Agenda
Village of Arlington Heights
Design Commission
Community Room, 3rd Floor

Arlington Heights Village Hall
33 S. Arlington Heights Road
Arlington Heights, IL 60005
February 9, 2016
6:30 PM

**MINUTES OF
THE VILLAGE OF ARLINGTON HEIGHTS
DESIGN COMMISSION MEETING
HELD AT THE ARLINGTON HEIGHTS MUNICIPAL BUILDING
33 S. ARLINGTON HEIGHTS RD.
JANUARY 26, 2016**

Job Name TNT'S SNACK SHOP
1706 W. CAMPBELL - ARLINGTON HEIGHTS
 Prepared 2/1/16 by LJF

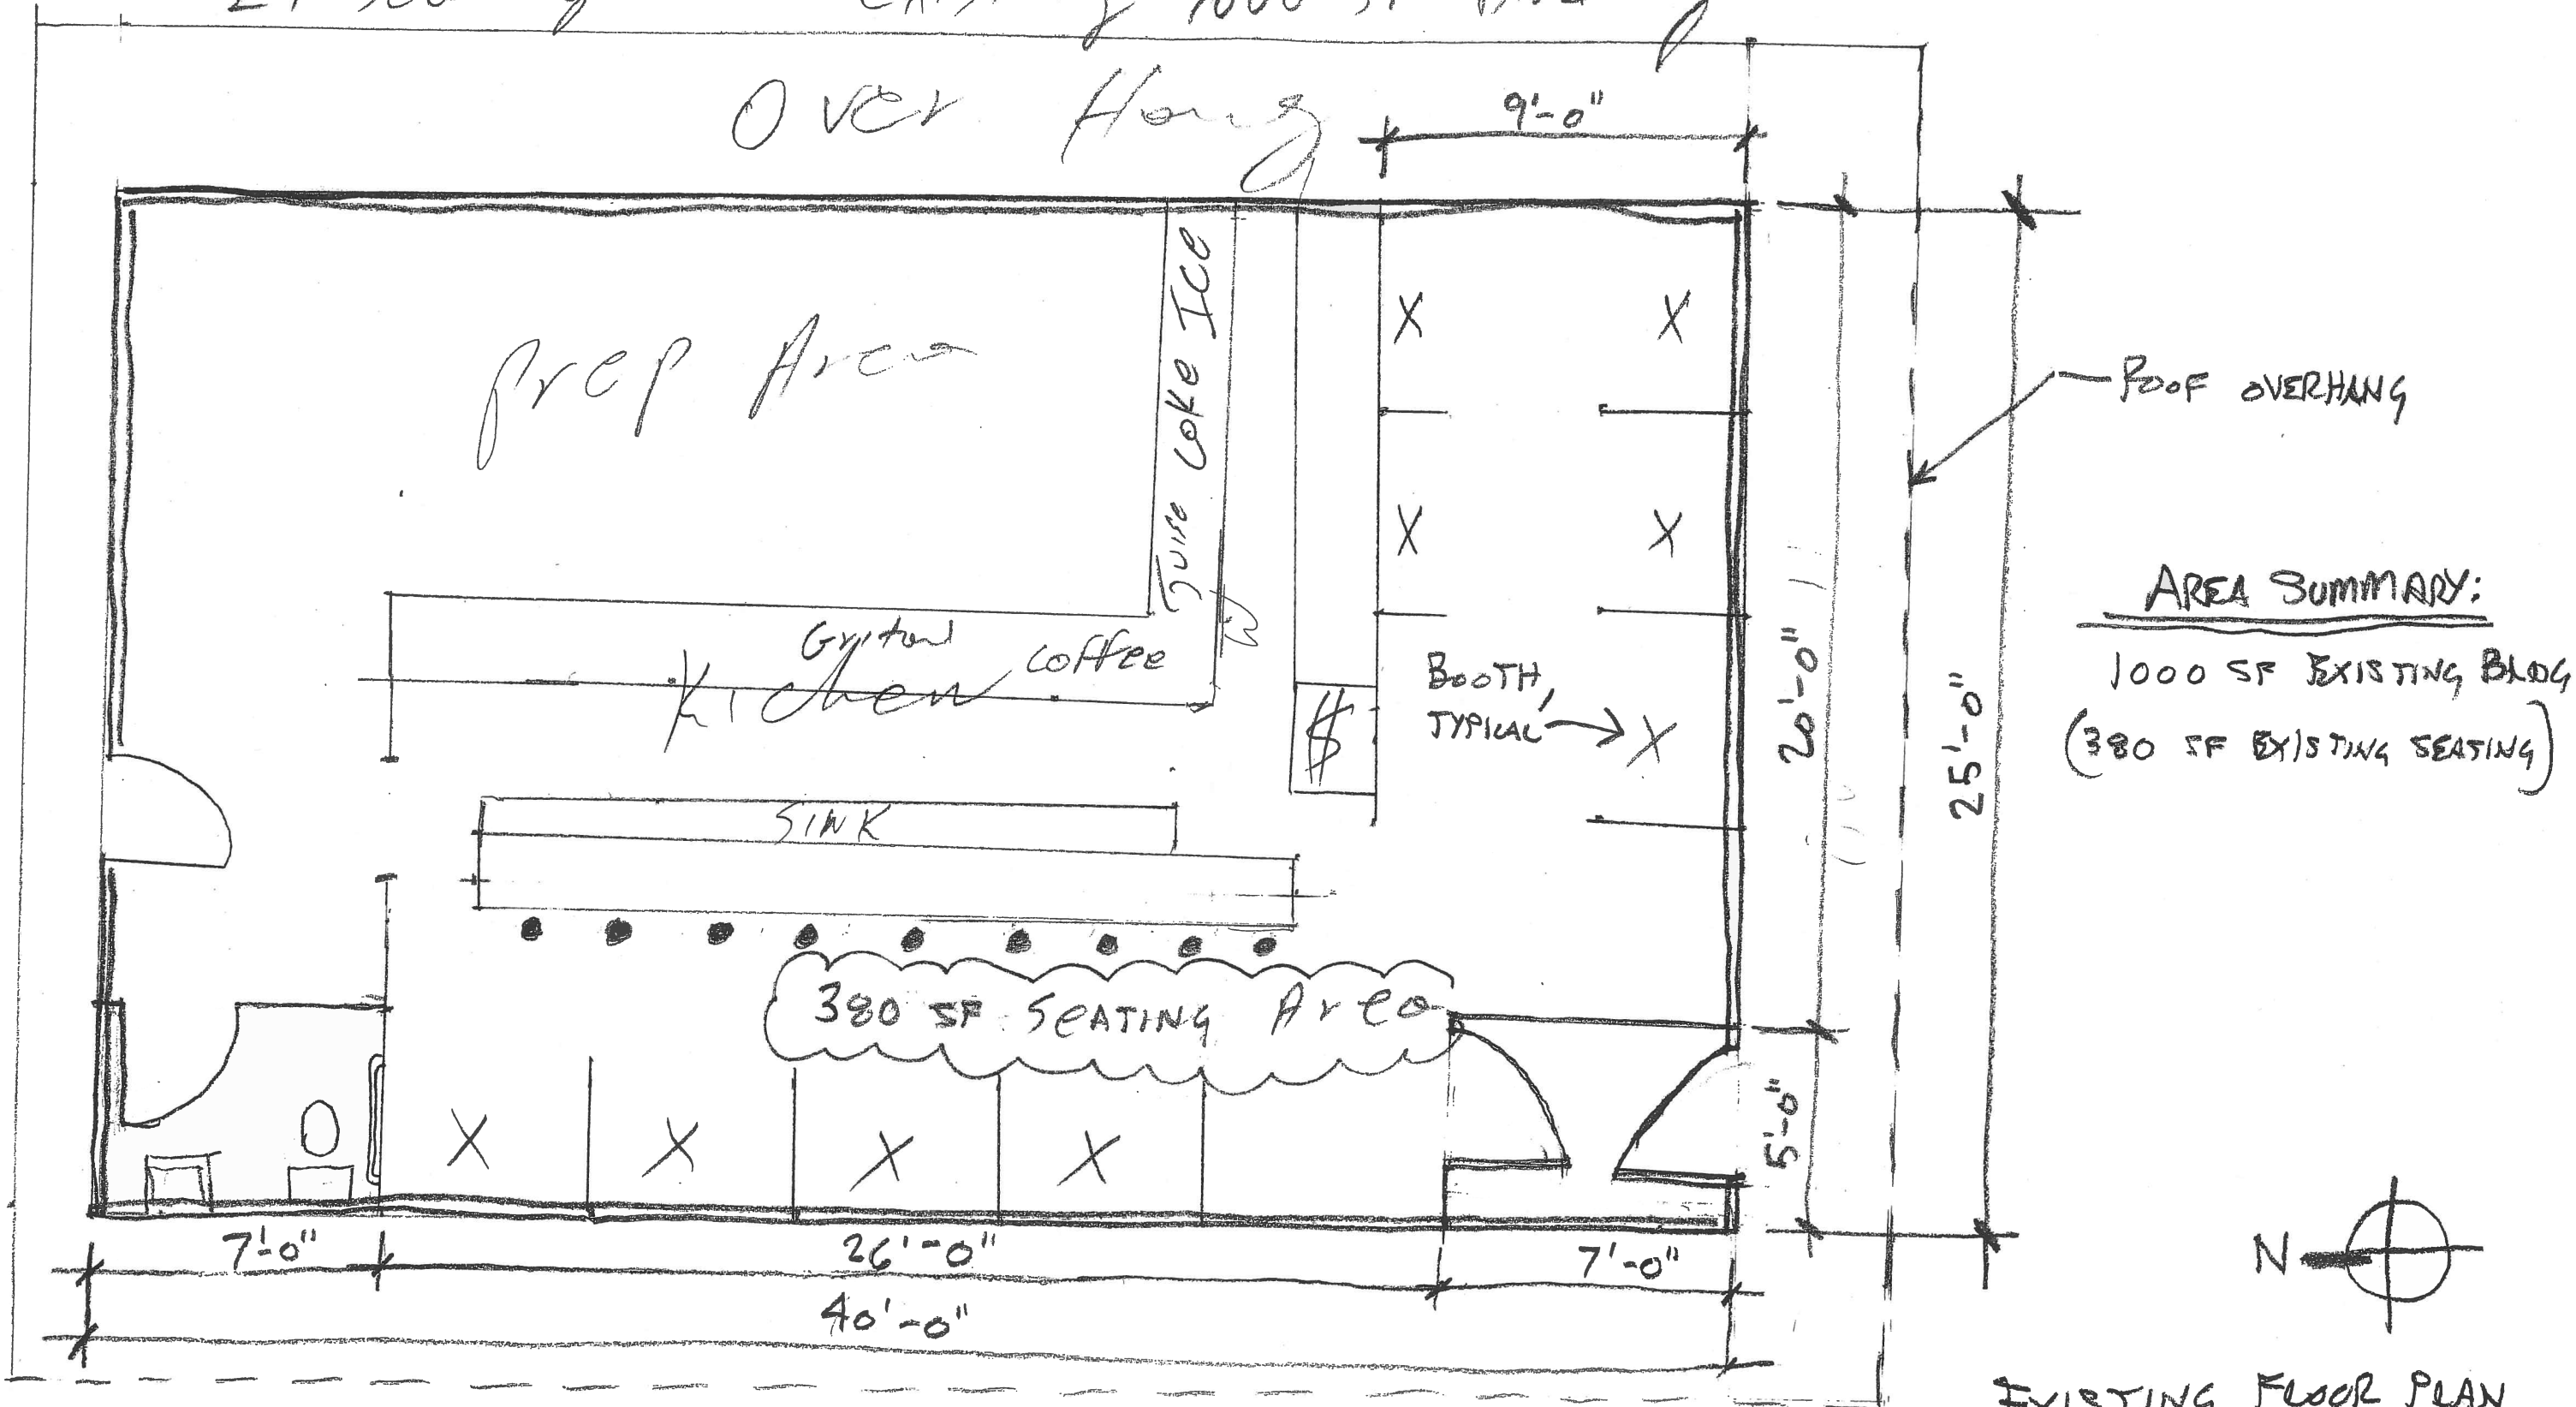
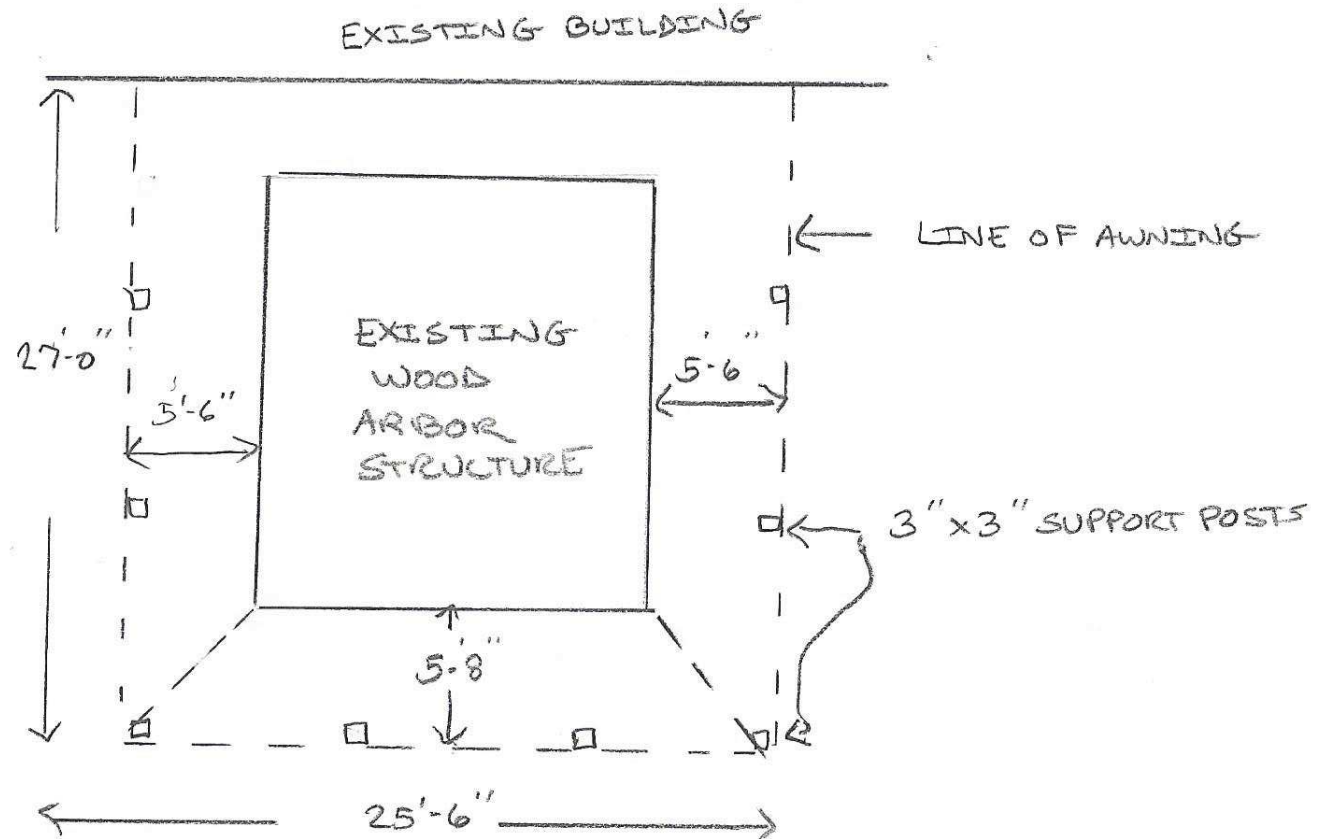
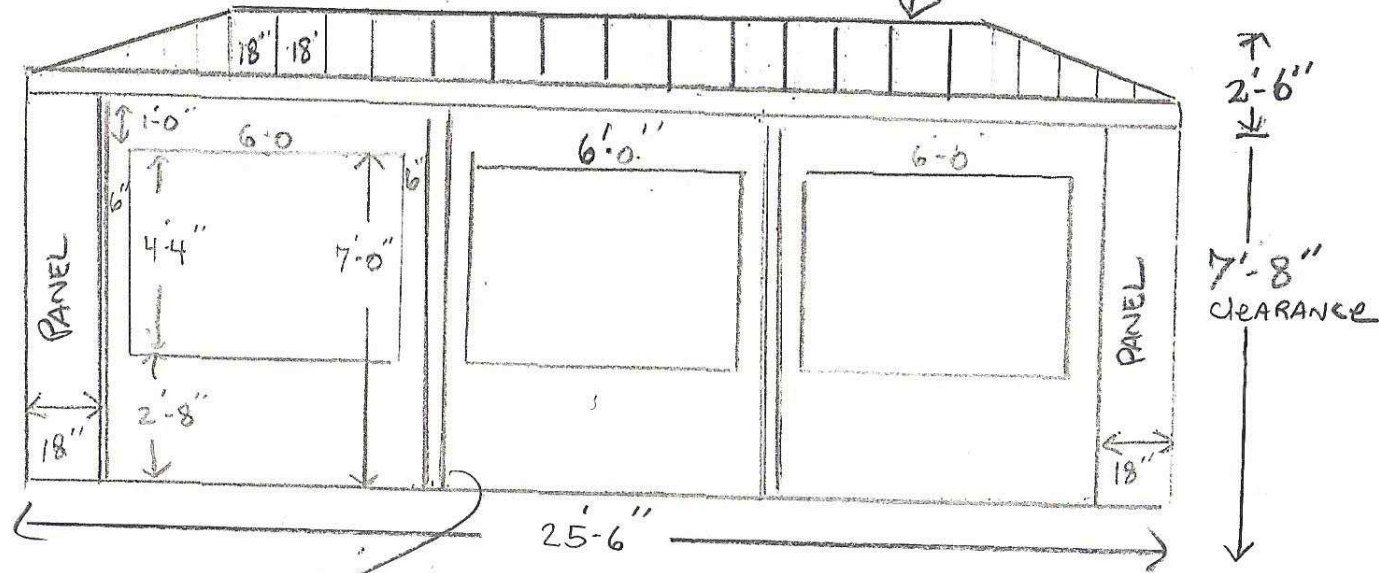
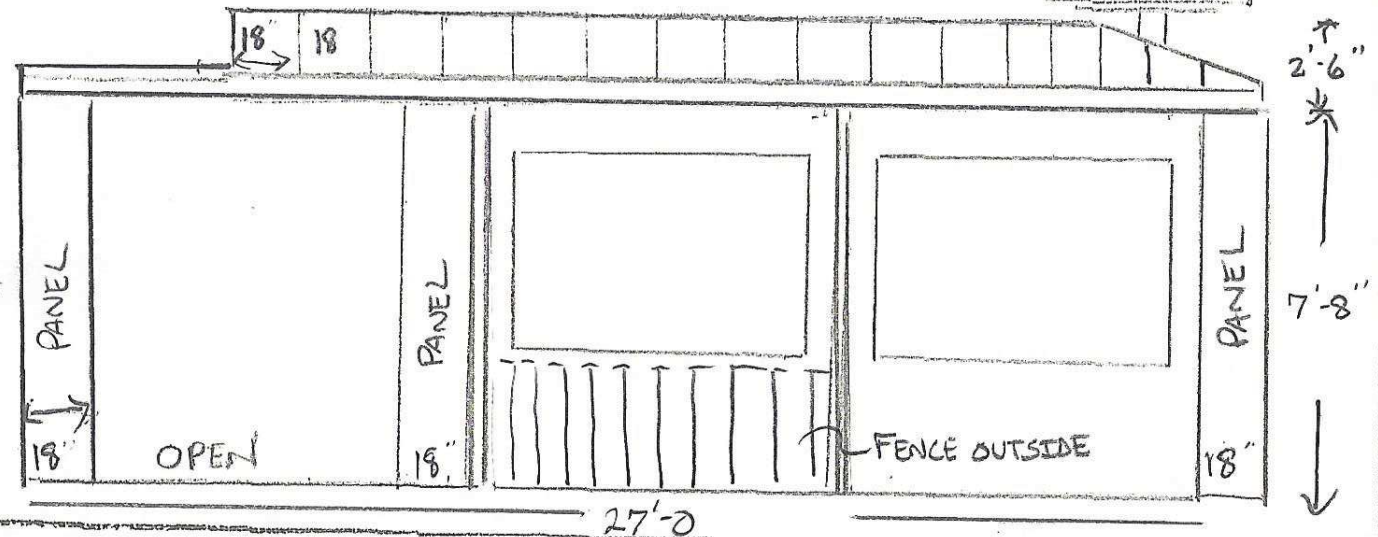
been omitted from the design. The awning is now proposed to be constructed of standing seam metal, instead of fabric. The proposed color has been modified from a bright red color to a slightly darker red color.

SHEET NO.
A1.0

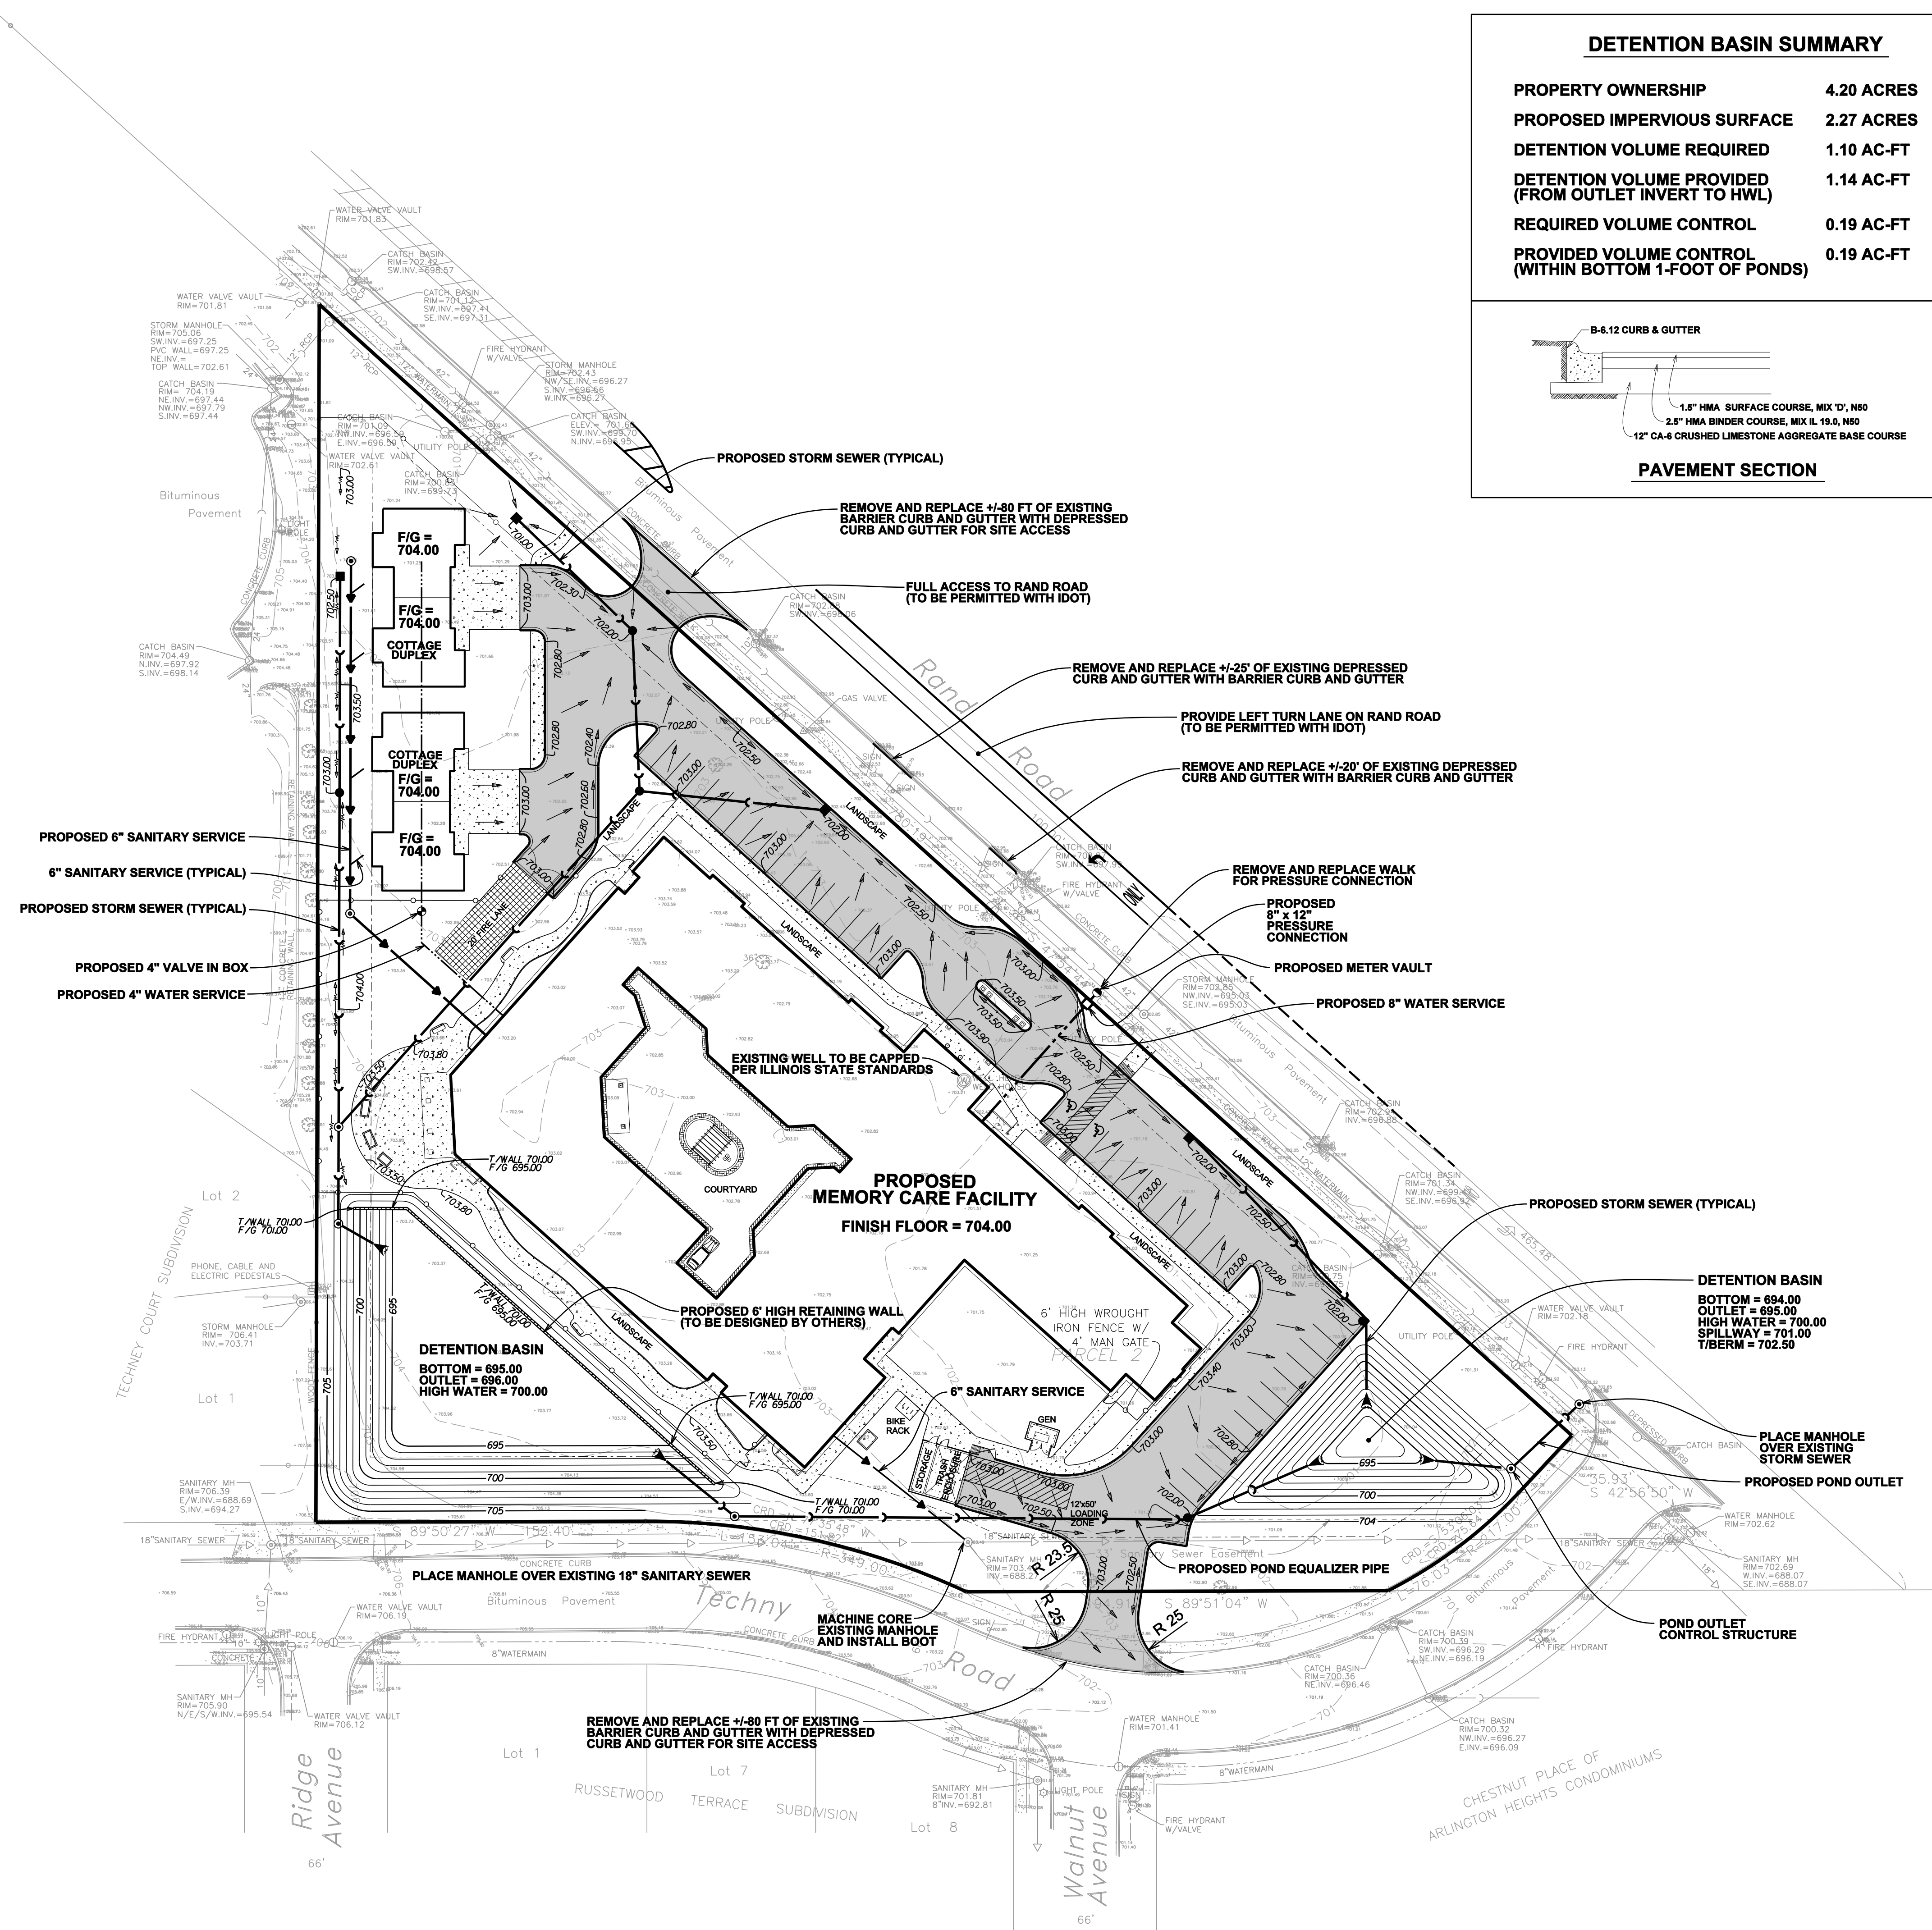
1. Consider providing specialty pavement in key areas such as the main building entrance and in front of the duplex cottages.
2. Consider incorporating site furnishings such as benches, trash cans, decorative lighting, and planters.

5. Consider providing specialty pavement in key areas such as the main building entrance and in front of the duplex cottages.
6. Consider incorporating site furnishings such as benches, trash cans, decorative lighting, and planters.
